# CONSERVATION DEPARTMENT DETAILED AGENDA

Date: June 2, 2022

PROPOSED SITE PLAN

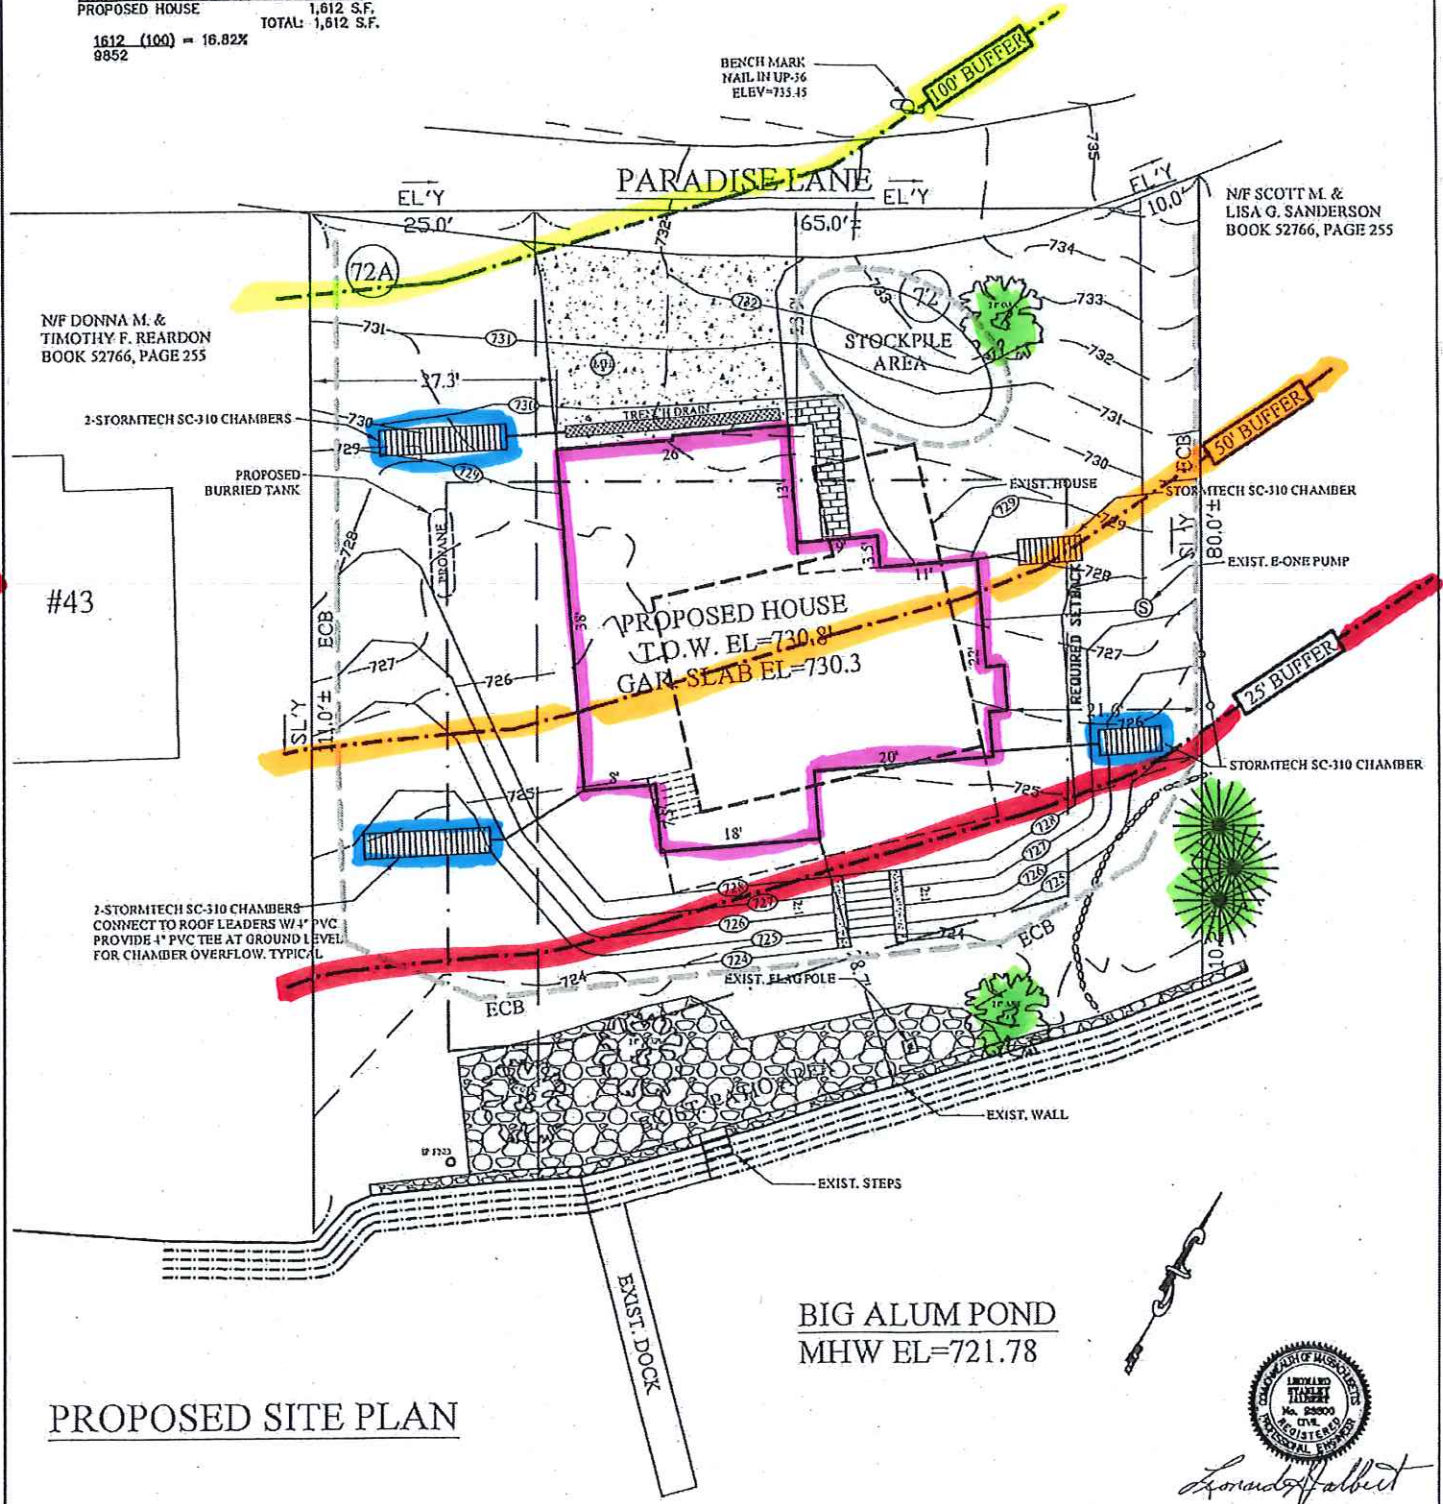
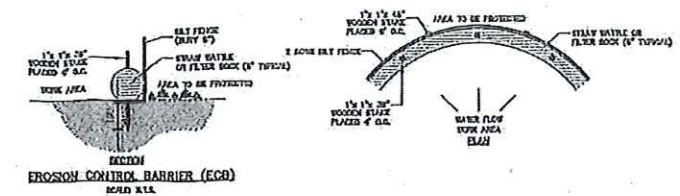
- Site contains BLSF and Bank, and is within the buffer zone to Bank. BLSF noted at 721.78 on the plan (MHW EL). Work is not proposed within BLSF. No trees noted for removal.

- Application does not include documentation outlining how the project meets standards for within the SWB nor an alternative analysis.
  - Project includes a reduction on the stone parking area and infiltration measures for stormwater from the roofs and driveway. Discharge locations of overflows not shown. How will overflow be handled? Location of perimeter drain not shown. Stormwater shall not be directed onto adjacent properties. Sizing of stormwater structures for roof and driveway should be demonstrated.

- Lot coverage increased and expansion is proposed within the 50 foot no new structure setback. Work is also proposed within the 25 ft. no disturb area. Lot is developed, however, fill noted within 25 ft. no disturb to raise the site. Work would require a waiver under the SWB. Project does not include an alternative analysis or information on how project meets requirements for a waiver. See SWB Regs (link above for requirements).

- A breakdown of the impervious surface increase within the 50 ft. BZ would be useful. Appears portion of structure pulled back from 25 ft. BZ line, however, sq. footage doesn't appear to be decreased within the 50 ft. BZ.

- As proposed, project does not appear to meet SWB permitting standards.

4. Staff Recommendation: Address notes above and continue to the next hearing, 6-23-22, as DEP has not issued a file. Applicant must demonstrate compliance with SWB standards.

PROPOSED SITE PLAN  
Located At: 88 SOUTH SHORE ROAD

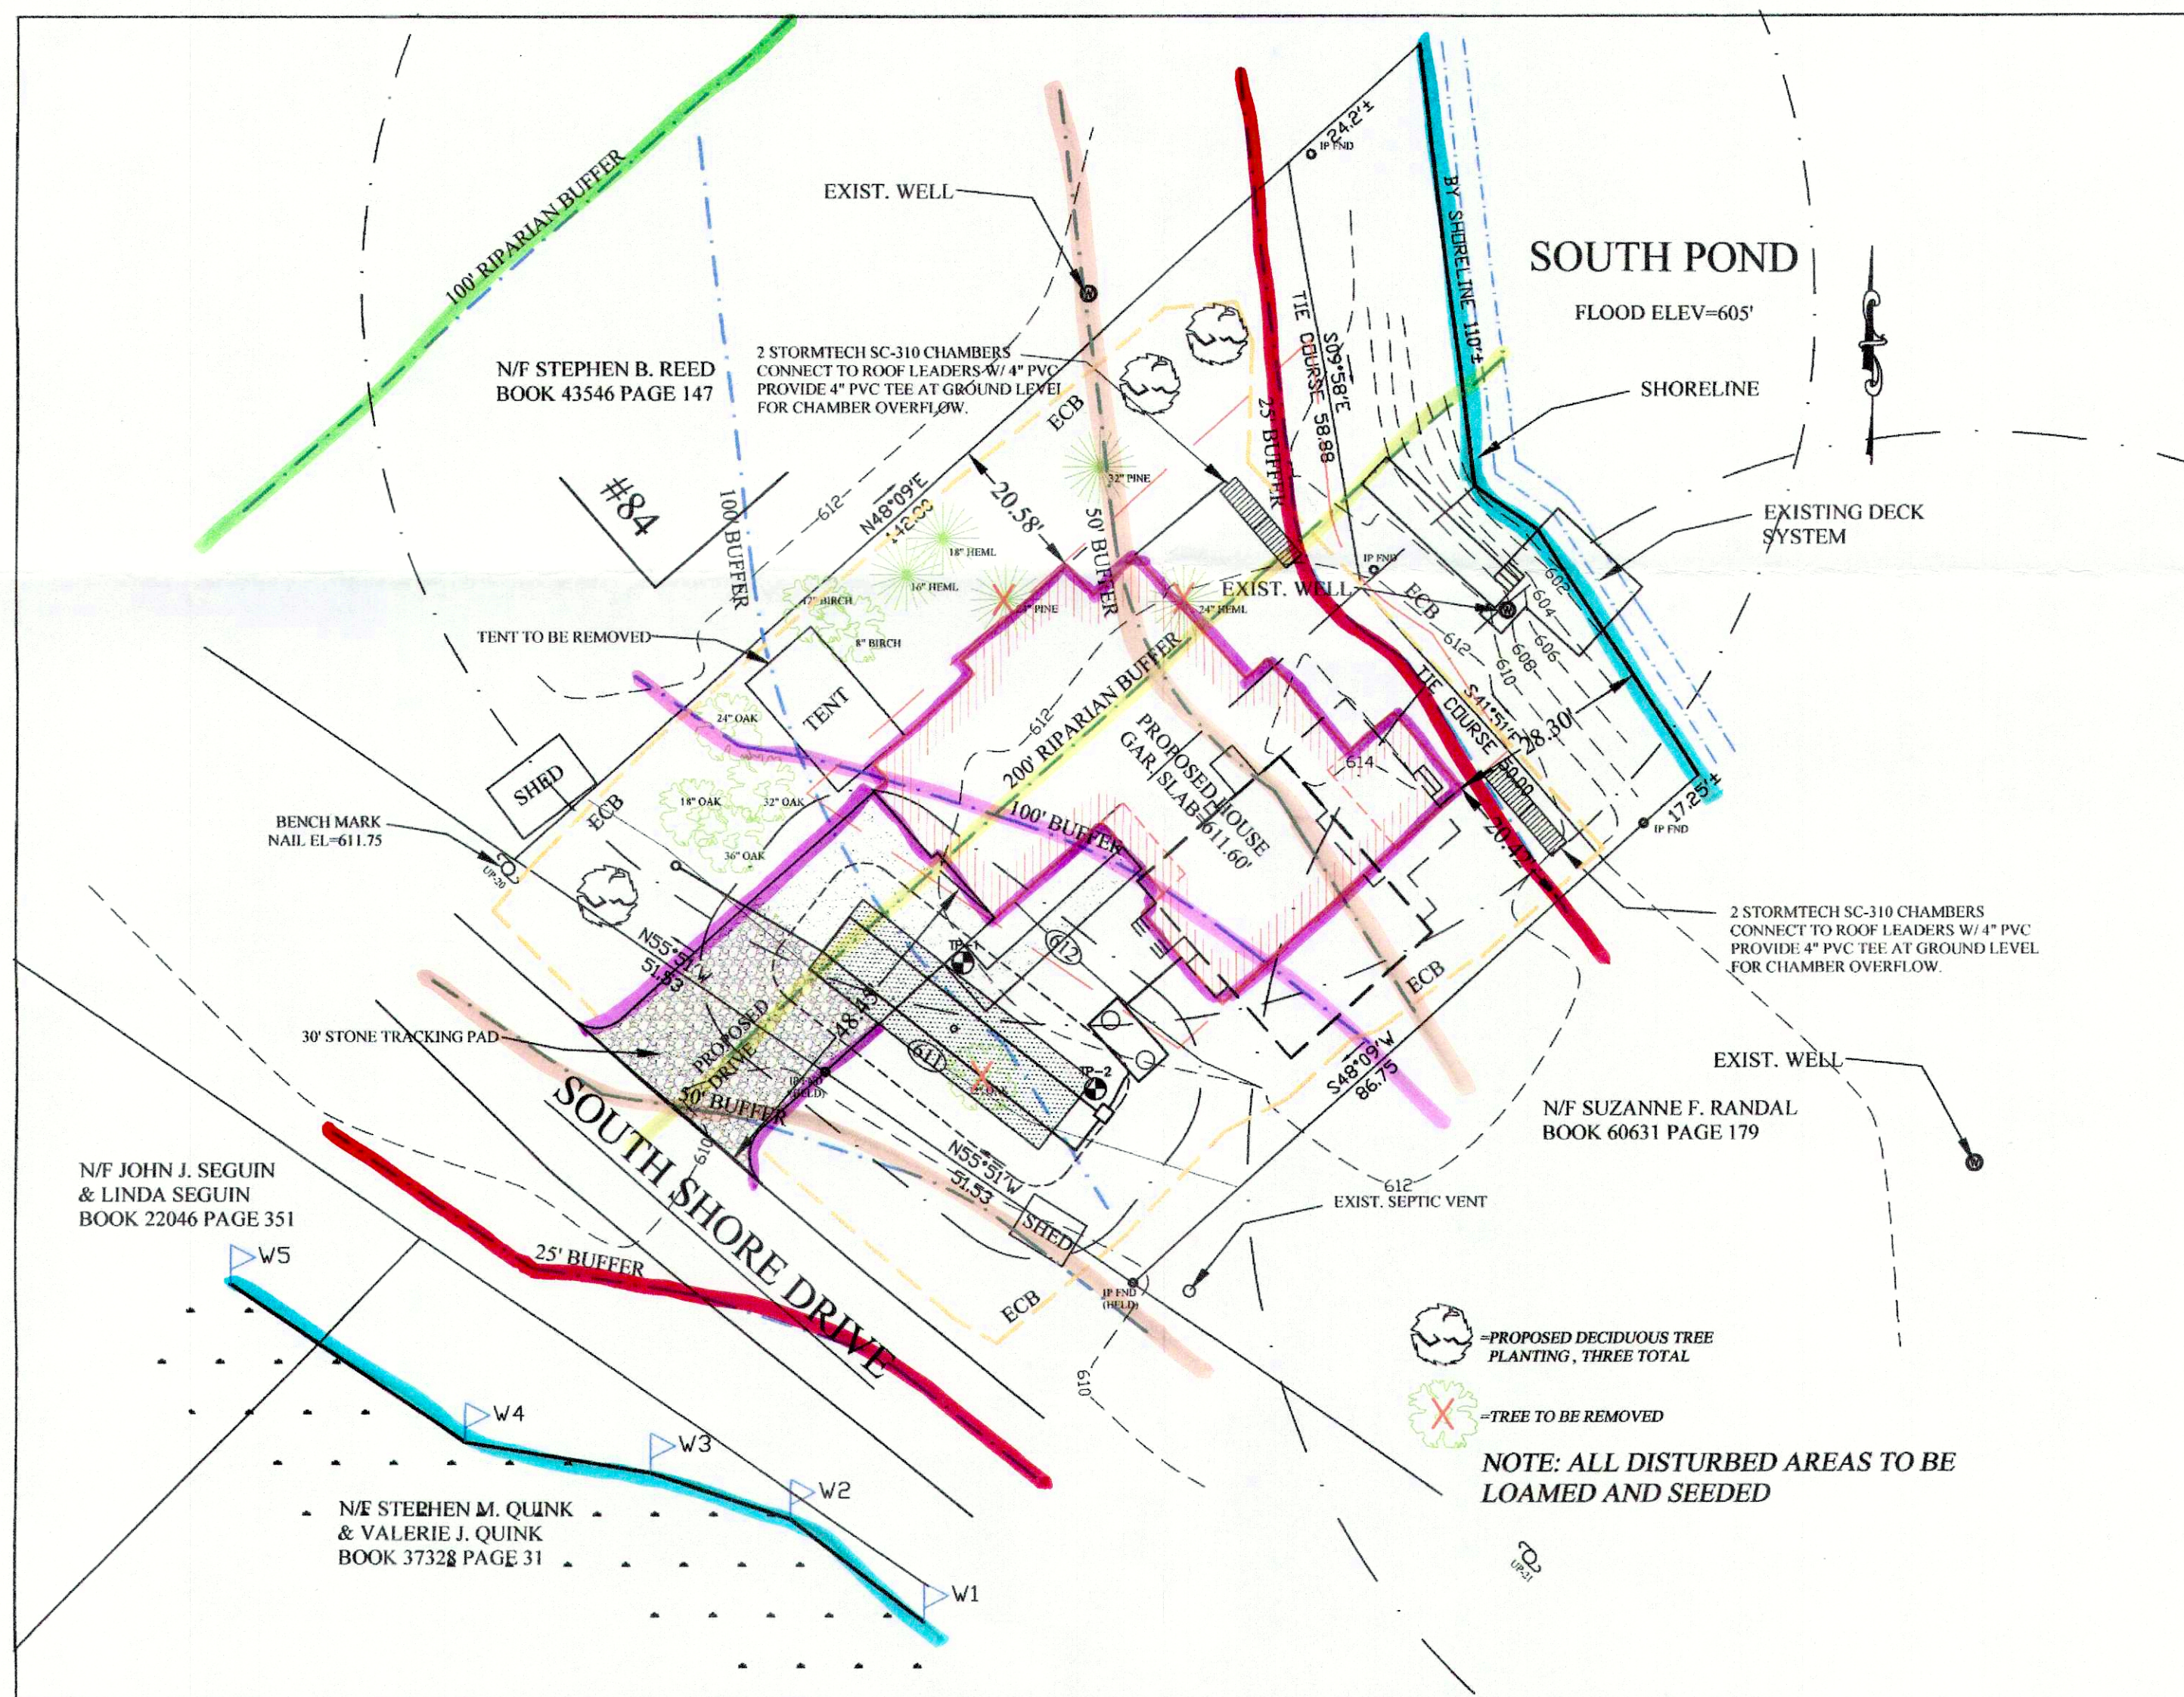
- No new information received on septic system and compliance with being within 100 ft. of a CVP. Engineer should provide written documentation of compliance for review. Board of Health was asked for comment. No written comment received to date. Per Title V Regs states that hydrogeological data...demonstrating that the location of the soil absorption system is hydraulically down gradient of the vernal pool is to be submitted to the issuance authority. Surface topography alone is stated to not be determinative.

- Reduction to RA impacts noted. Would appear to be more amenable to the WPA and SWB RA standards. House footprint shifted to reduce impacts within RA and to utilize more previously developed area within the 50 ft. no new structure setback. House size does not appear to have been reduced. Same footprint just shifted. Site is restrictive for building footprint locations due to resource areas, setbacks and septic location.

- Project includes infiltration measures for stormwater from the roofs and driveway. Discharge locations of overflows not shown. How will overflow be handled? Location of perimeter drain not shown. Stormwater shall not be directed onto adjacent properties. Sizing of stormwater structures for roof and driveway should be demonstrated in writing.

- 3 trees to be removed and replaced with 3 deciduous trees. Sizes shall be documented. Should be at least 1.5" dbh. New septic and size of house adds constraints to citing additional trees to meet the 2:1.

- Board should evaluate if revisions are acceptable to meet all concerns. Would appear that a second story on the house for secondary bedrooms would reduce the footprint and may be an option for demonstrating compliance with the SWB 50 ft. no new structure setback and/or less bedrooms.

- Revised plan is an improvement over last. However, as proposed, the project does not appear to meet SWB permitting standards for work within 50' no new structure setback. See SWB Regs. 365-1.1E.- H.; 365-1.2, 365-1.3 (see: <https://ecode360.com/35319582>)

- Staff Recommendation: Written information regarding compliance for septic with vernal pool shall be demonstrated prior to issuance of a decision as this can have a significant impact on the project. The board may wish to have the applicant demonstrate why a second story or smaller house (alternative analysis/option) isn't feasible. Continue hearing to next meeting to allow representative to address comments. The next meetings is on 6-23-2022.
